Re: *Invenergy Docket No. SB-2015-06*

**INVENERGY THERMAL DEVELOPMENT LLC'S RESPONSES TO
THE RHODE ISLAND DEPARTMENT OF ENVIRONMENTAL MANAGEMENT'S
FIRST SET OF DATA REQUESTS**

**CLEAR RIVER ENERGY CENTER
FUEL OIL SECONDARY CONTAINMENT
PRELIMINARY CONCEPTUAL
PLAN AND SECTION**

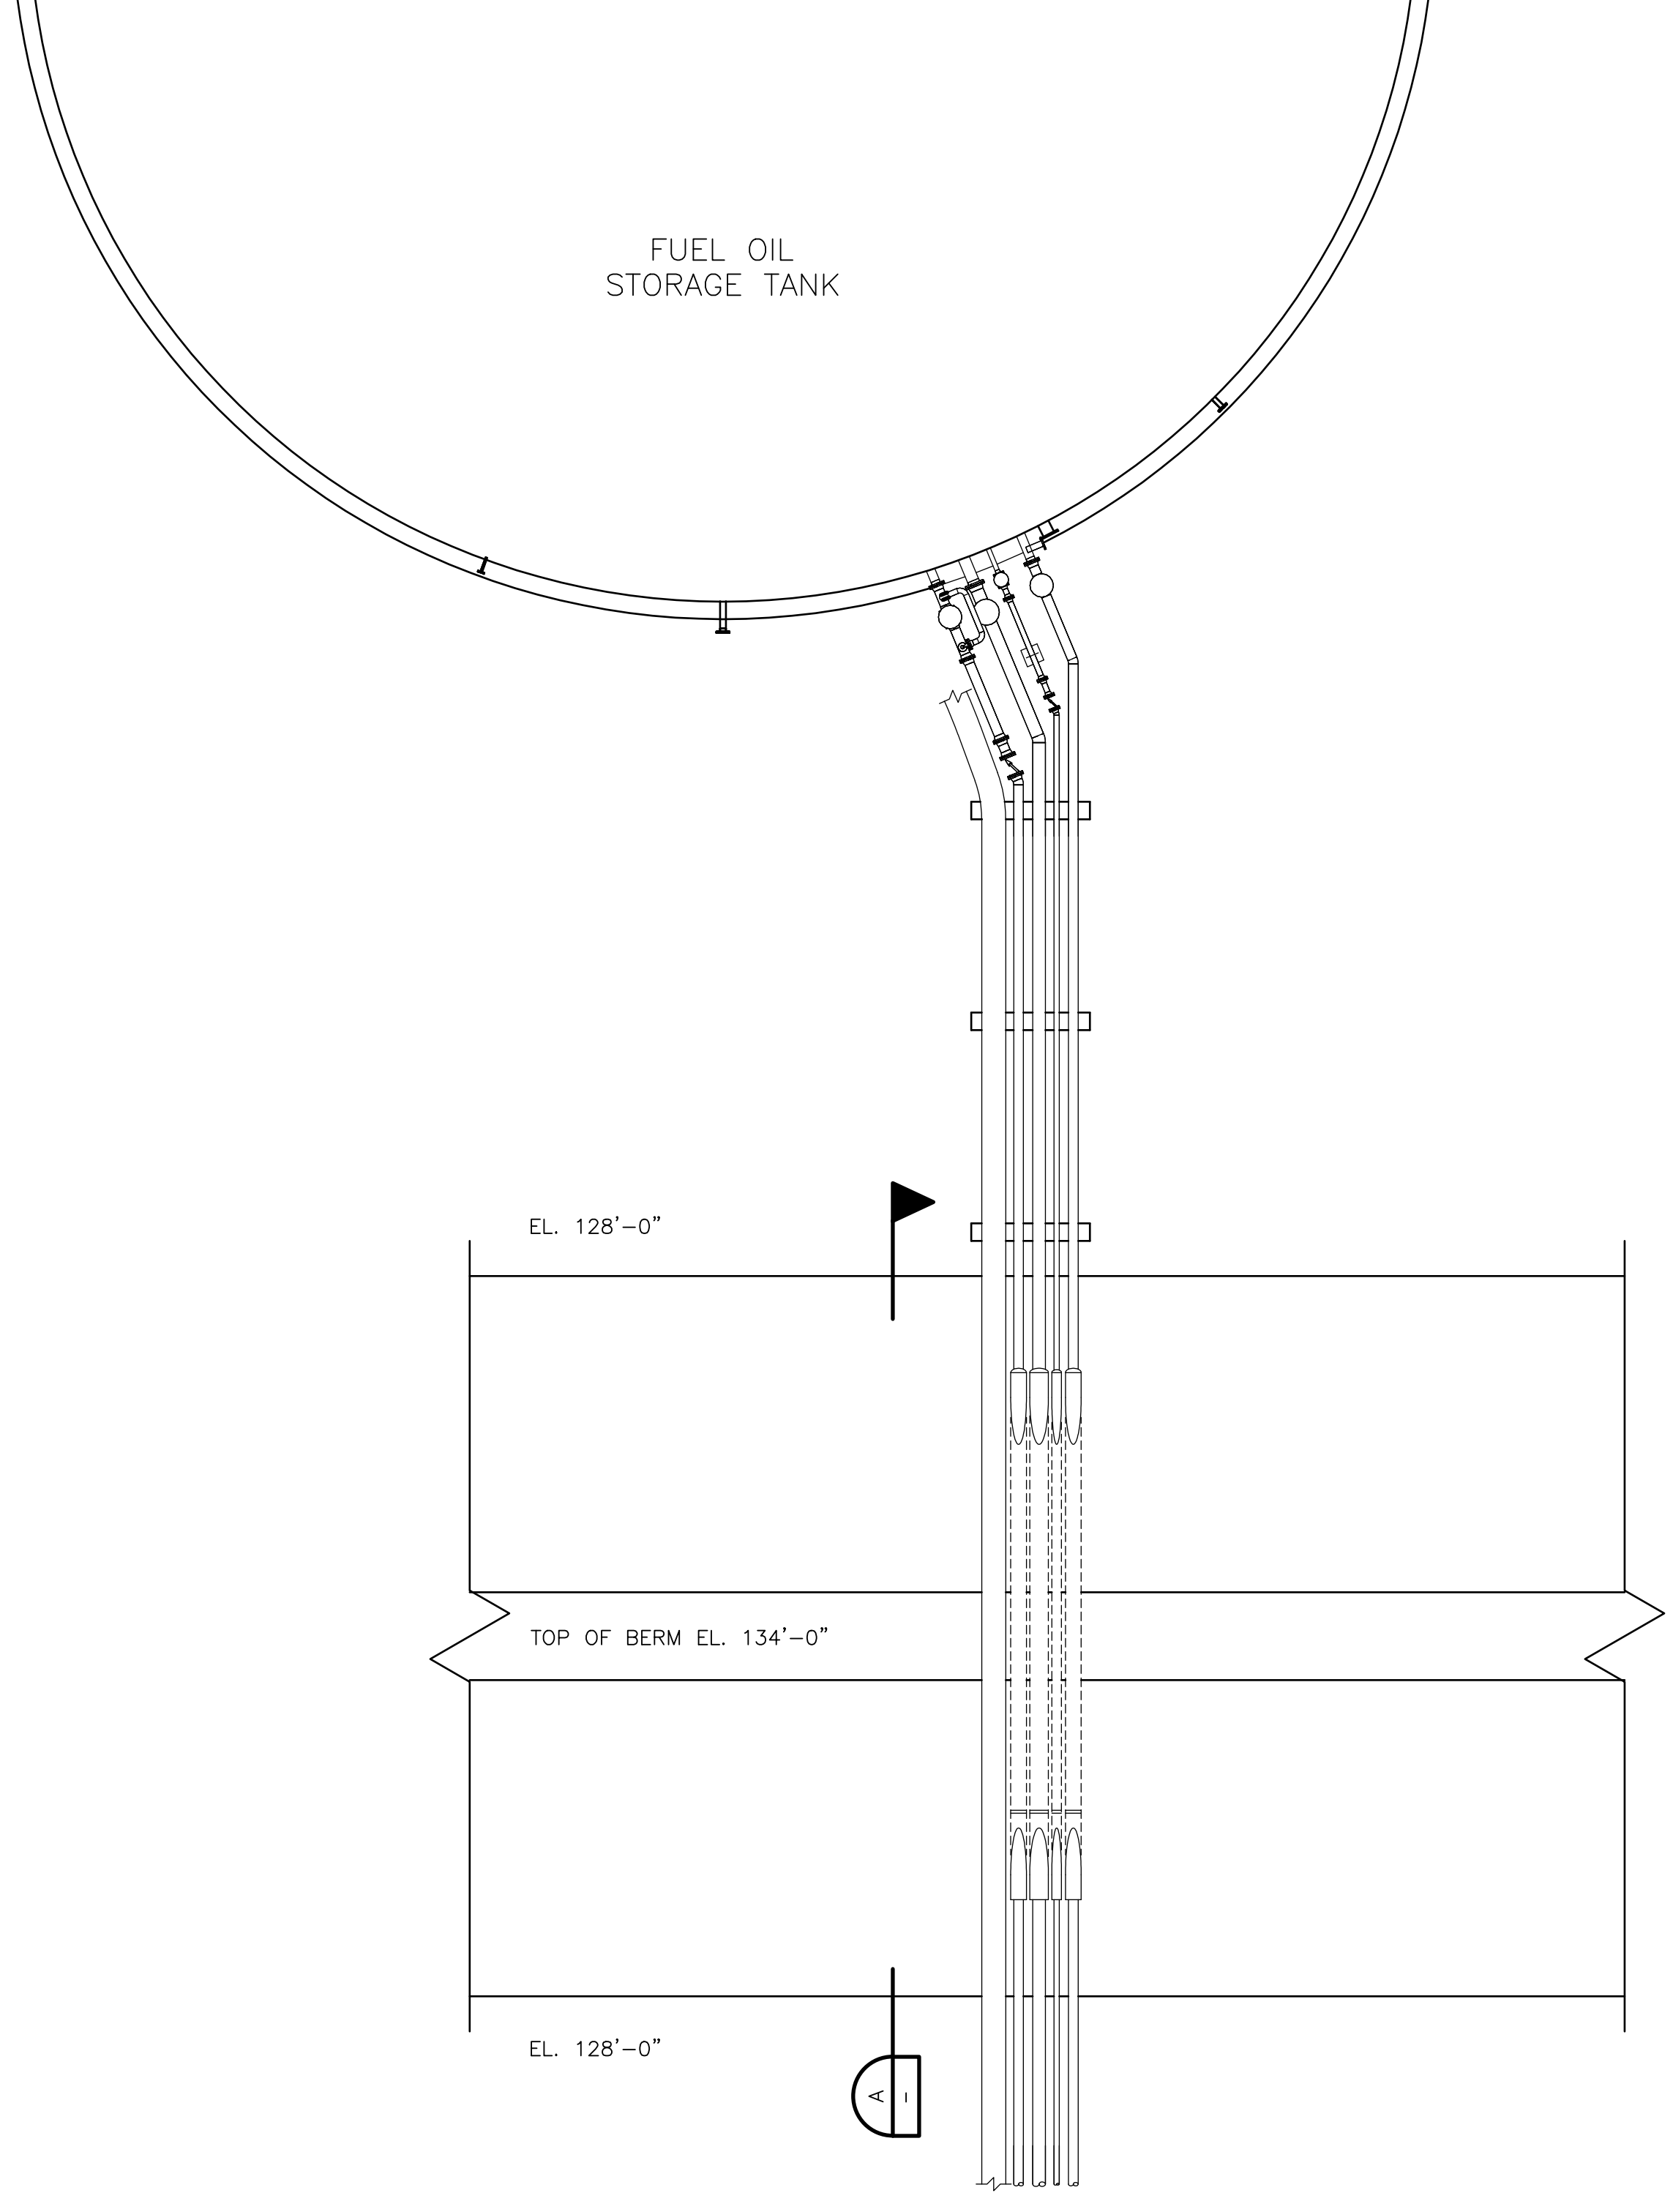
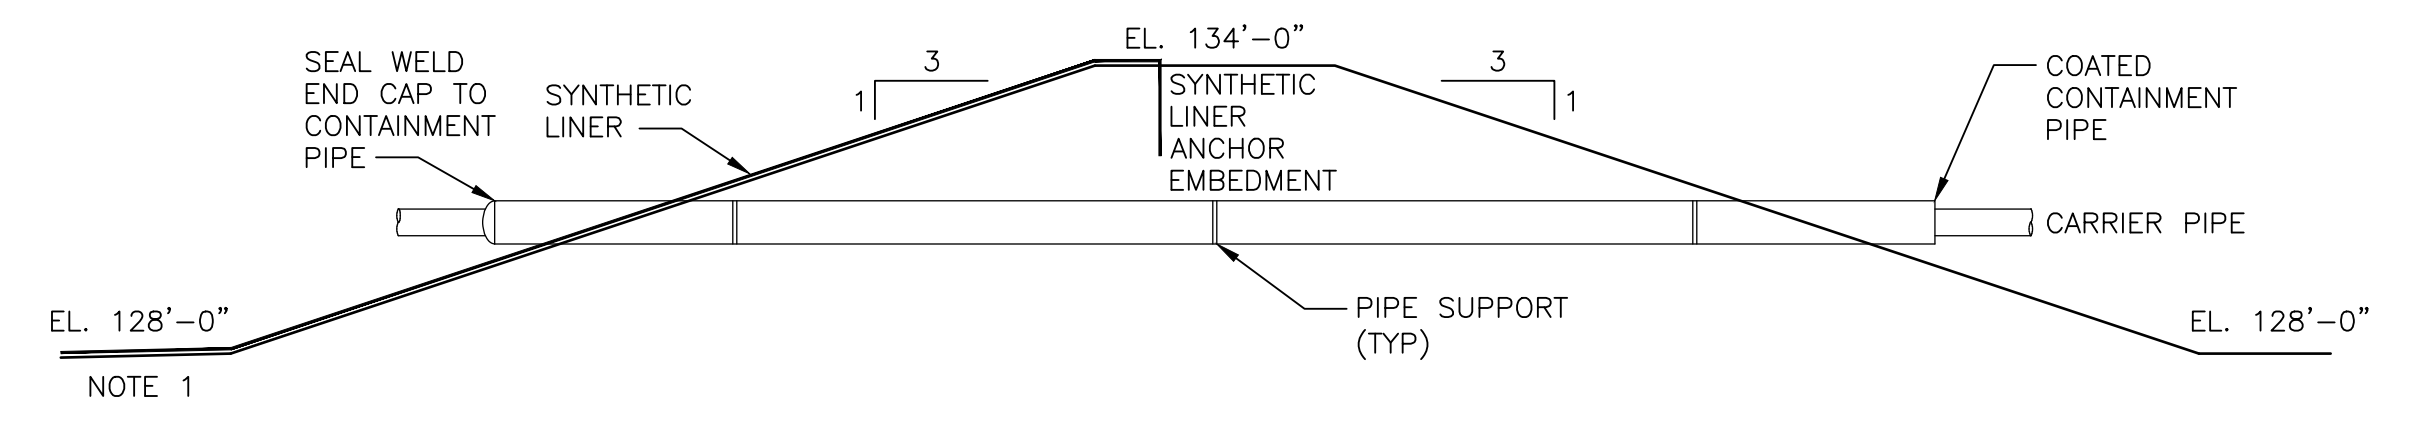
1-13 Please provide a detail description and diagram for secondary containment systems for ASTs at the facility. *See OPC Regulations Section 10(i)(5).*

RESPONSE: 1-13 As discussed in Question 1-12, the fuel oil ASTs will include either a berm/liner or ring wall containment system.

For a berm system, the berm will be a built with soil berm with an oil tolerant membrane (synthetic liner) and covered with minimum of 4 inches of stone ballast. The liner will have water permeability equal to or less than 1×10^{-6} cm/sec.

For a ring wall system, the ring wall will be constructed of welded steel plate around the perimeter of each AST. The ring wall will rest on a concrete foundation installed around the perimeter of the tank to form an impermeable containment. The volume of the space between the AST and the ring wall will be sufficient to hold 110% of the AST volume.

**Monitoring Well Schematic (typ.)
(Unconsolidated Deposits)**

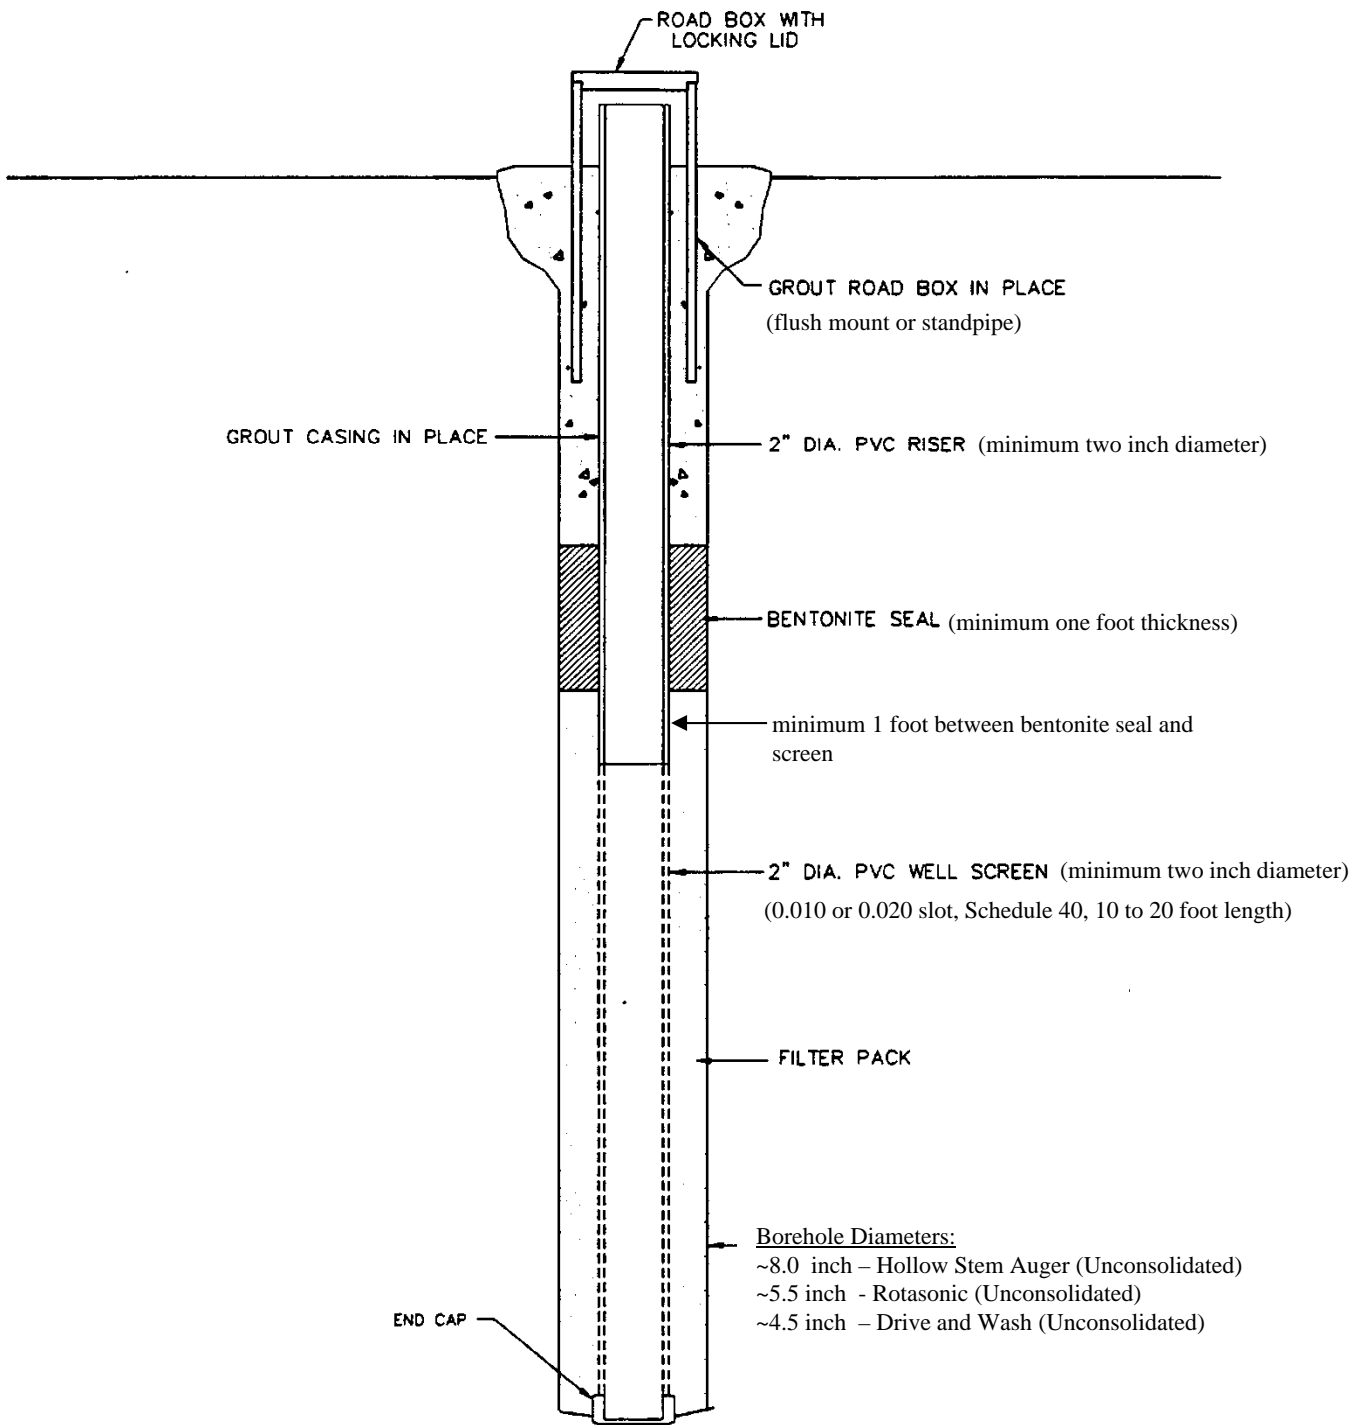
1-8 Please provide a detail description and diagram for ground water monitoring wells including construction standards. *See OPC Regulations Section 10(h)(1)*

RESPONSE: 1-8 The CREC groundwater monitoring wells will be designed to meet the well construction standards of OPC Regulations Section 10(h)(1). All wells will be screened both above and below the water table with screened intervals sufficient to detect free phase product over the full range of expected seasonal water table fluctuations. Each well will be at least 2 inches in diameter and be equipped with a locking tamper proof cover. The CREC groundwater monitoring plan will be submitted to RIDEM along with the Aboveground Storage Tank (AST) Registration Form. The AST Registration for the CREC ULSD storage tanks will be submitted once the design of the tanks and piping systems have been completed.

A schematic showing a typical monitoring well design is attached as **Exhibit 2**. Monitoring wells will be located around the perimeter of the secondary containment system for the ASTs and along the pipeline from the ASTs to the combustion turbine fuel oil combustion systems at intervals acceptable to RIDEM.
